Report to the Future Melbourne (Planning) Committee**Agenda item 6.3****Ministerial Planning Referral: TPM-2022-1
Lot B, 473-505 Docklands Drive, Docklands****12 July 2022****Presenter:** Marjorie Kennedy, Head of Statutory Planning**Purpose and background**

Application number:	TPM-2022-1
DELWP Application number:	PA2101470
Applicant / Owners / Architect:	Hollerich Town Planning / MAB Corporation / Wood Marsh Pty Ltd
Address:	473-505 Docklands Drive, DOCKLANDS VIC 3008
Proposal:	Construction of a multi-storey apartment development and provision of car parking that exceeds the requirements of the Parking Overlay
Cost of works:	\$160,000,000
Date received by City of Melbourne:	6 January 2022
Responsible officer:	Xavier Livy, Principal Urban Planner

Figure 10: Concern with use of vertical louvres to screen podium car parking for western elevation

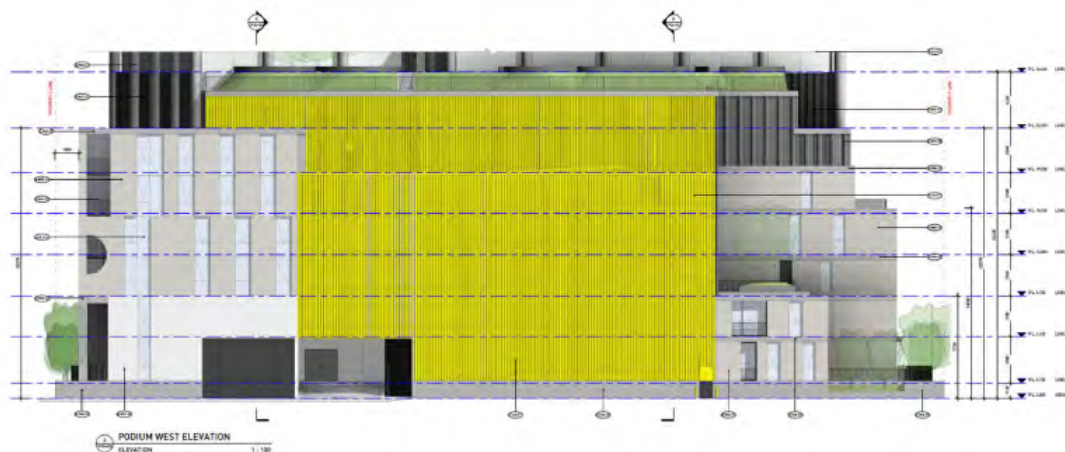
- Sliding doors should be used in lieu of revolving doors.
- Further refinement of the car parking interface is required to avoid the use of vertical louvers which can be seen in Figure 10 below.

- Further details and design measures for the Wattle Road and shared zone interface which can be addressed as a part of any public realm plan.
- Alternative material to the car parking screening within the podium to improve visual interest.

- Further details on the proposed materials which can be addressed in a Façade Strategy.
- Removal of revolving doors, to replace with sliding doors to create a more pedestrian friendly environment.

Figure 22 – Location of the sea wall in the context of Lot B

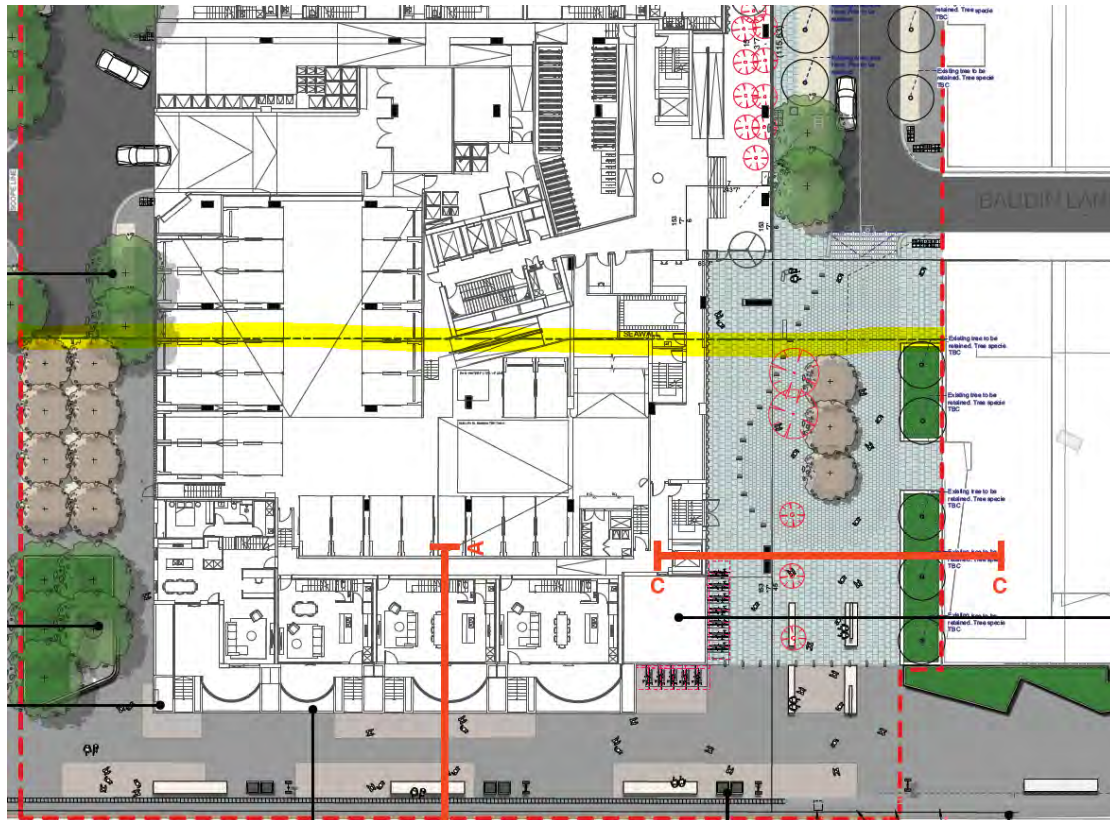
Given the impact of the seawall on the ability to provide deep soil, this provision is not met. Notwithstanding, deep soil areas are proposed along the northern street frontage, with a series of planter boxes used along the southern façade at ground floor, at various spots on the upper levels of the podium, and throughout the common open space area on top of the podium. These areas are anticipated to meet the

canopy cover provision of Standard D10 and include one Type C tree (in the south east corner), one Type B Tree (in the south west corner) and numerous Type A trees throughout the site and on top of the podium.

Figure 24 – Non-compliant Dwelling Type P-B

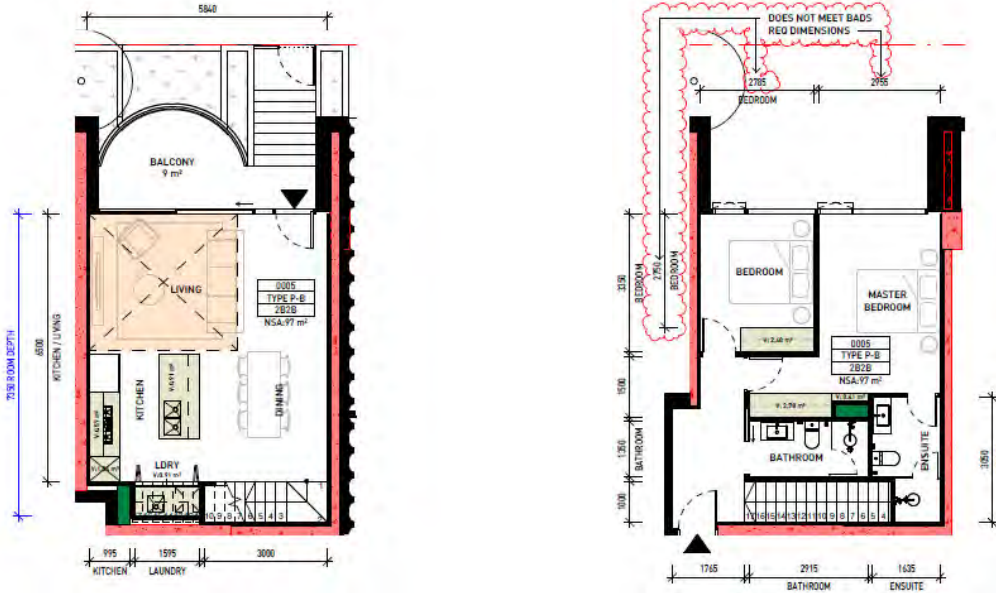
type (terrace) has a positive outlook to future public open space it is considered its internal amenity could be improved which could be addressed via a condition on any permit issued.

A condition of the Officer recommendation addresses this item. Subject to the proposal achieving compliance with the recommended condition the development will achieve full compliance with Standard D26.
